RE: Skagway Ore Peninsula Redevelopment Descoping Pricing

Please find attached Pacific Pile & Marine's (PPM) proposal for the Skagway Ore Peninsula Redevelopment De-Scoping Pricing based on drawings received 07/05/2023 and discussions thereafter.

ORE PENINSULA REDEVELOPMENT
SKAGWAY, ALASKA

TEMP FUEL LINE PLAN

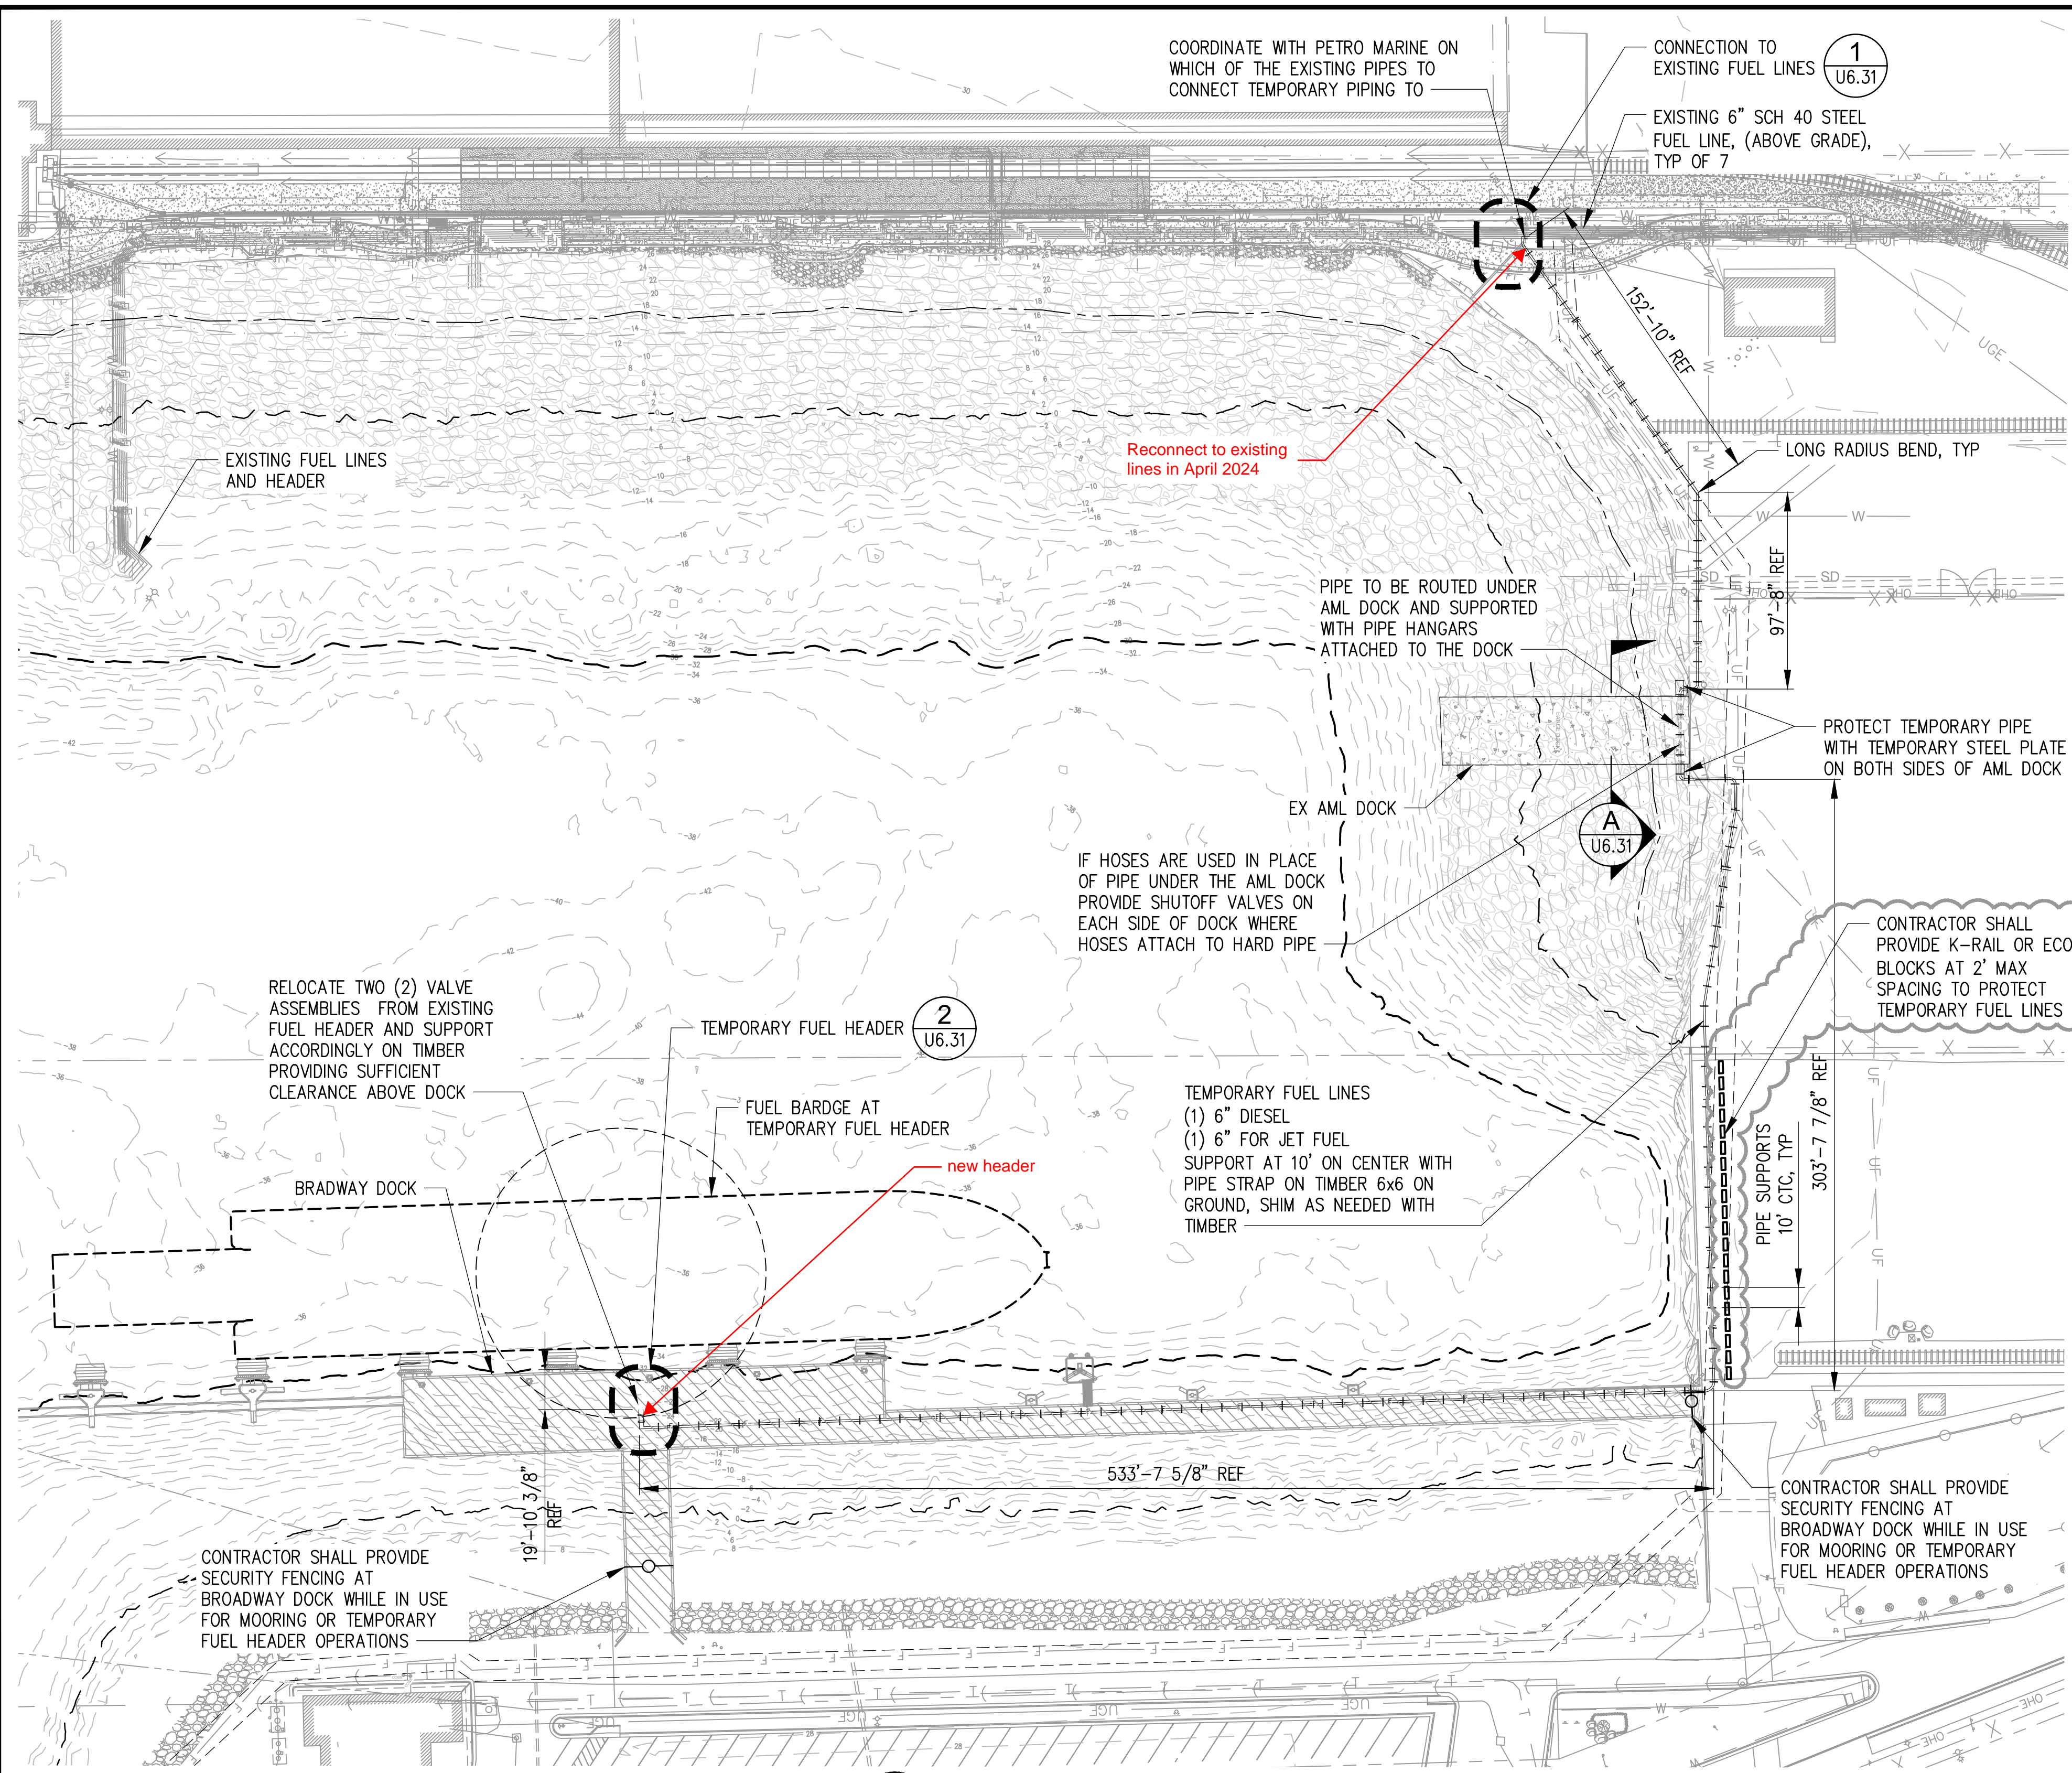
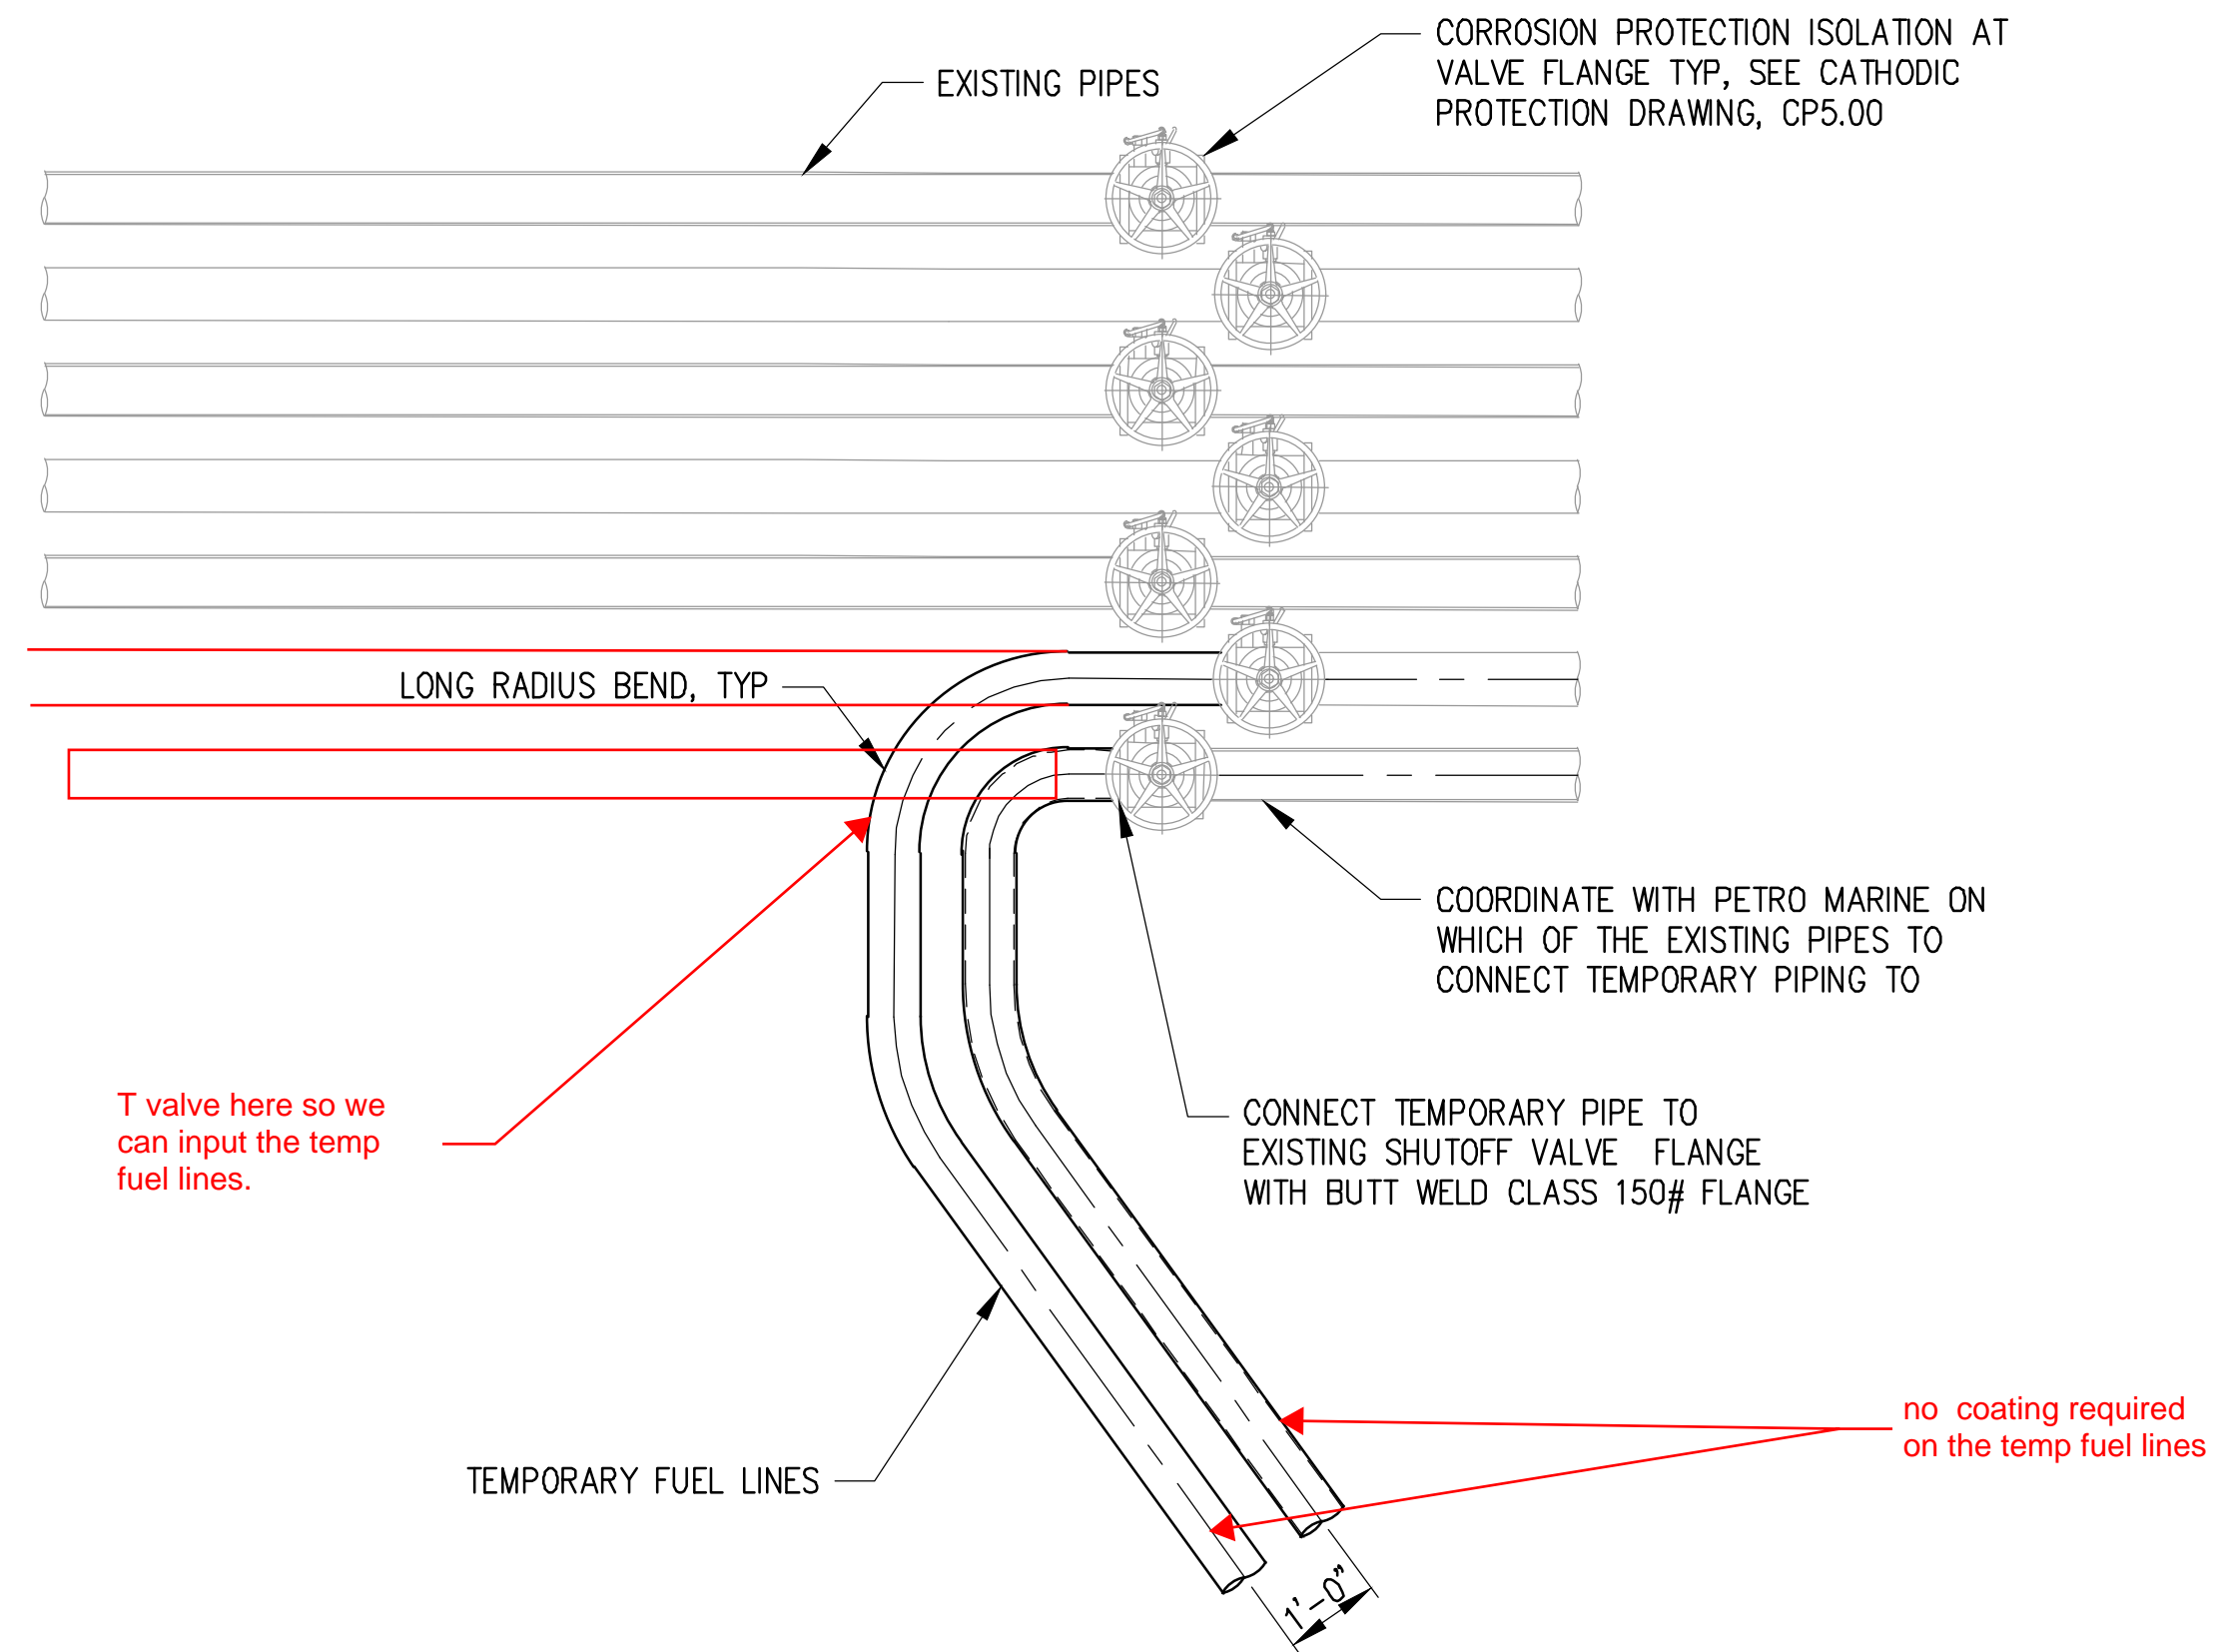
TEMP FUEL LINE RE-SCOPE 7.7.2023
